CITY of NOVI CITY COUNCIL

Agenda Item 6
January 21, 2014

SUBJECT: Consideration of the request of Toll Brothers, Inc. for The Preserve at Island Lake JSP13-69, for approval of the proposed Seventh Amendment to the Residential Unit Development (RUD) Agreement and Plan. The subject property to be included as part of the amendment is 48.95 acres of land located at the northeast corner of Ten Mile Road and Napier Road. The applicant is proposing a 45-unit single family development that would be Phase 8 of the existing Island Lake of Novi development.

PLANNING REVIEW

Figure 4: Drakes Bay System Curve – Short-Term Upgrades

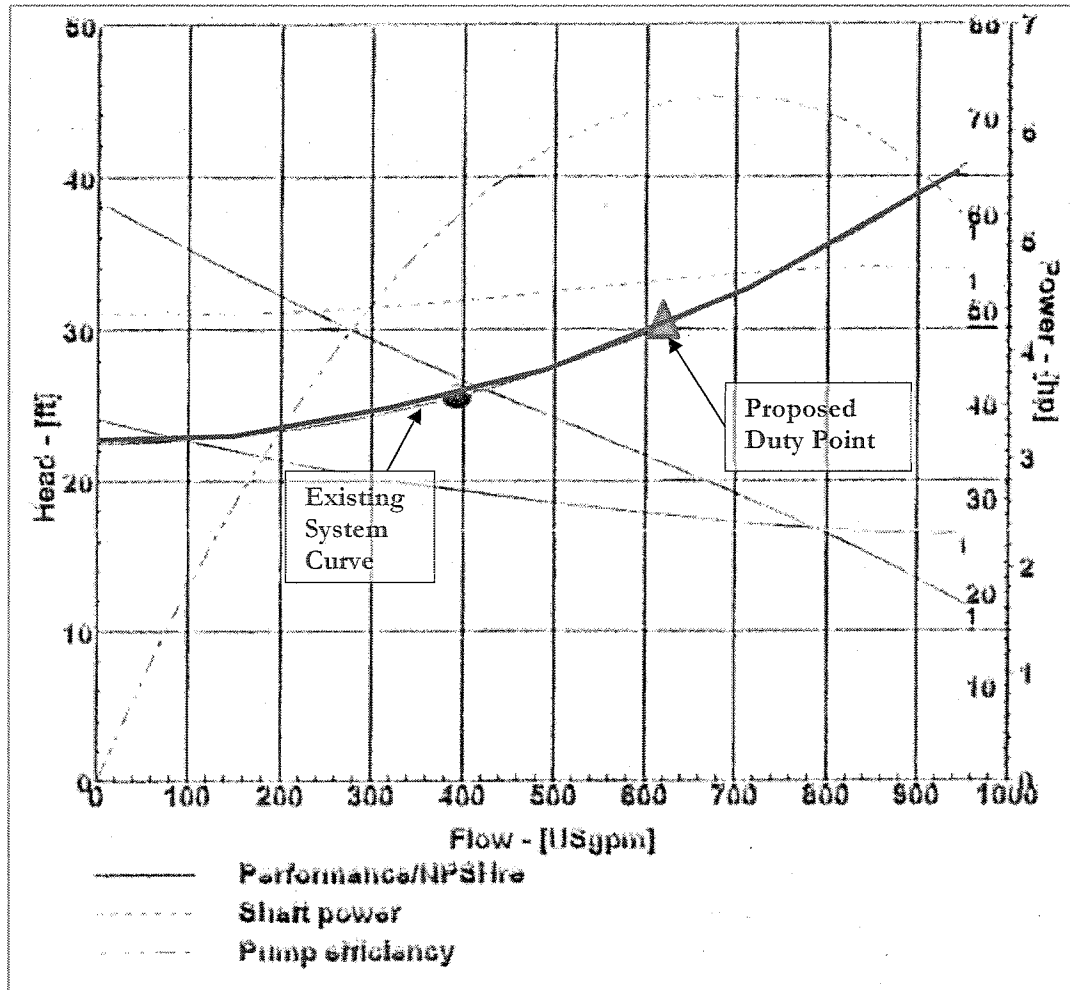
1. Short-Term Upgrades are needed to the Station to increase the capacity to 1.38 cfs (620 gpm). The existing system curve for the Station is presented in Figure 4.

The system curve calculations should be verified, but assuming that the original system curve was computed correctly, the proposed duty point for the upgrades is 1.38 cfs (620 gpm) @ 31 ft. TDH. It will be necessary to evaluate whether the existing pumps can be fit with a larger impeller, or if larger pumps are necessary to accommodate the new duty point. If larger pumps are needed, it will also be necessary to verify that the existing wet-well (6 ft. diameter) and electrical systems (including generator) are large enough to accommodate larger pumps.

Figure 5: Drakes Bay System Curve – Full Build-Out Upgrades

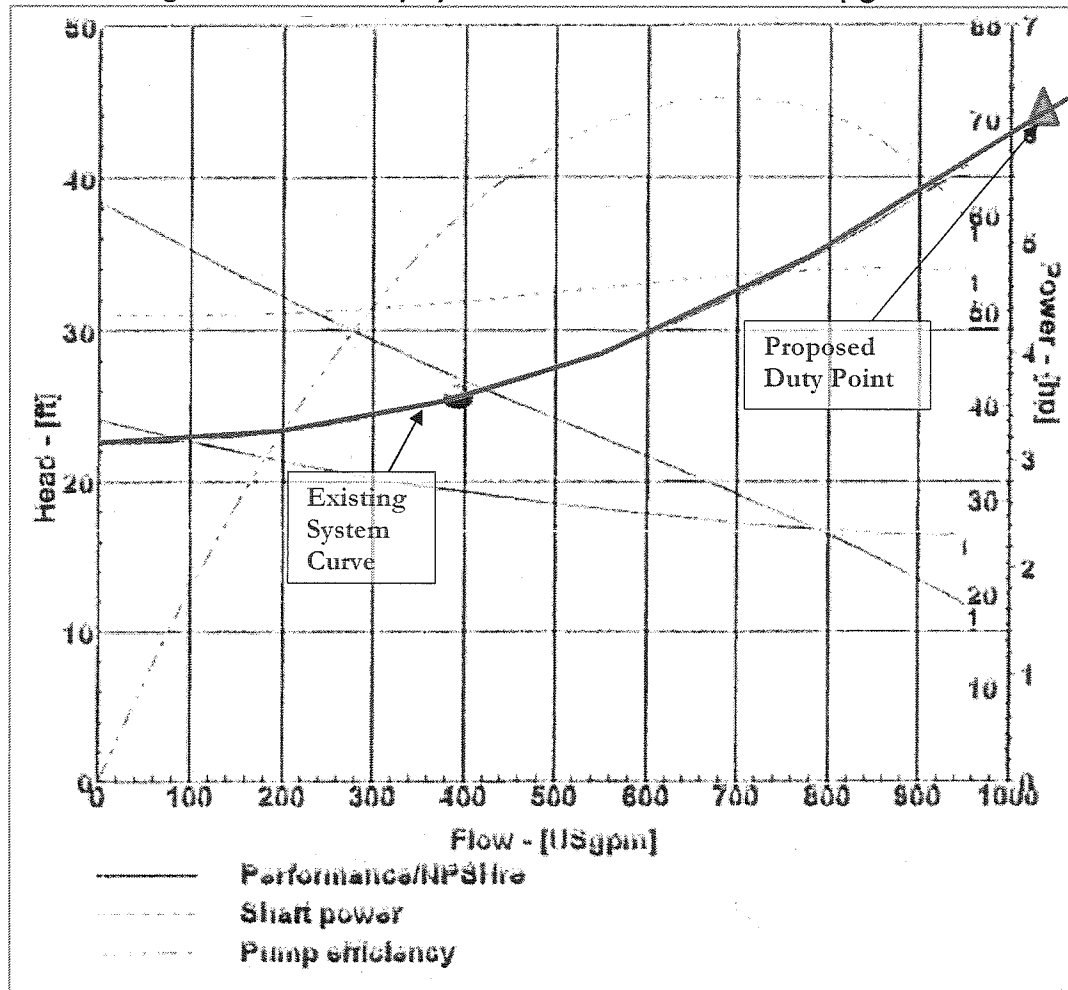
2. Full Build-Out Upgrades are needed to the Station to increase the capacity to 2.53 cfs (1,135 gpm). The existing system curve for the Station is presented in Figure 5.

Assuming that the original system curve was computed correctly, the proposed duty point for the upgrades is approximately 2.53 cfs (1,135 gpm) @ 45 ft. TDH. Larger pumps will be necessary to accommodate the full build-out duty point. It will be necessary to verify that the existing wet-well (6 ft. diameter) and electrical systems (including generator) are large enough to accommodate larger pumps. For future build-out conditions, a capacity analysis of the receiving sewer downstream of the Drakes Bay Pump Station should be performed to evaluate if upgrades are needed to this sewer. The existing 12-inch receiving sewer has a nominal capacity of 1.95 cfs and the future build-out design flow from the Drakes Bay Pump Station is 2.53 cfs. This finding indicates upgrades are needed to this portion of the collection system. The capacity analysis for this portion of the system will be summarized in a separate "Wixom Road System Capacity Analysis" technical memo.

Figure 1. Approximate wetland locations (portion of Overall Topographic Survey, prepared by Alpine Engineering and dated September 23, 2013).

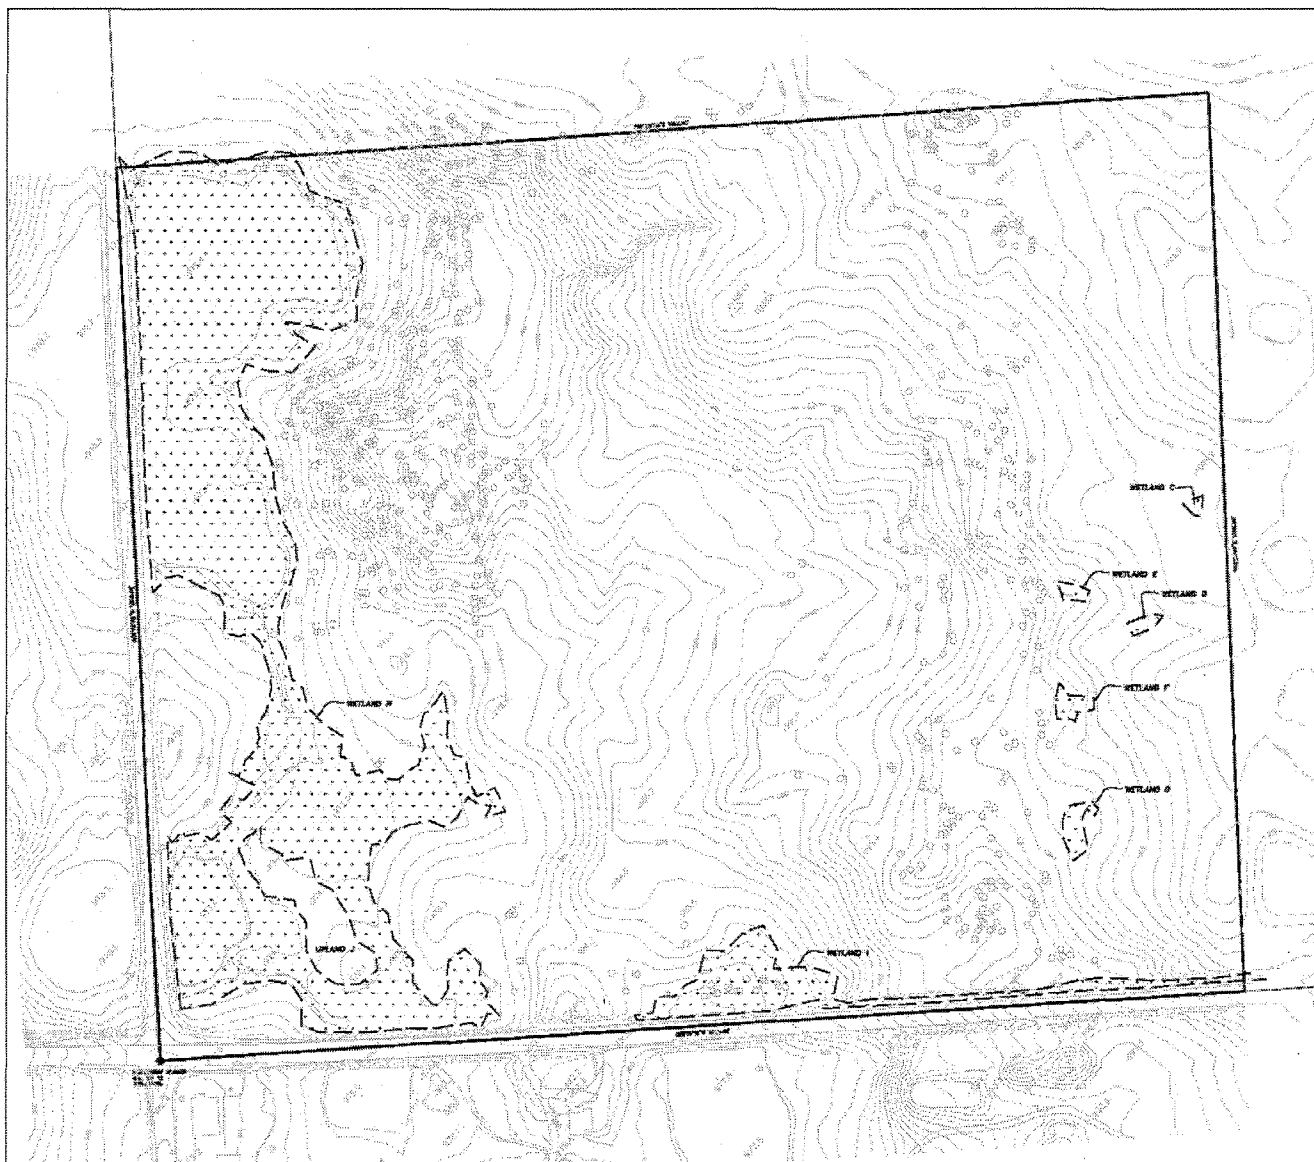
As previously noted, seven (7) areas of wetland exist on this parcel totaling 7.21 acres of wetland (wetland locations are shown in Figure 1, attached). The following table summarizes the existing wetlands and the proposed wetland impacts as listed on the *Preliminary Site Plan Overall Grading Plan* (Sheet 9):

In addition to wetland impacts, the Plan also specifies impacts to the 25-foot natural features setbacks. The following table summarizes the existing wetland setbacks and the proposed wetland setback impacts as listed on the *Preliminary Site Plan Overall Grading Plan* (Sheet 9):
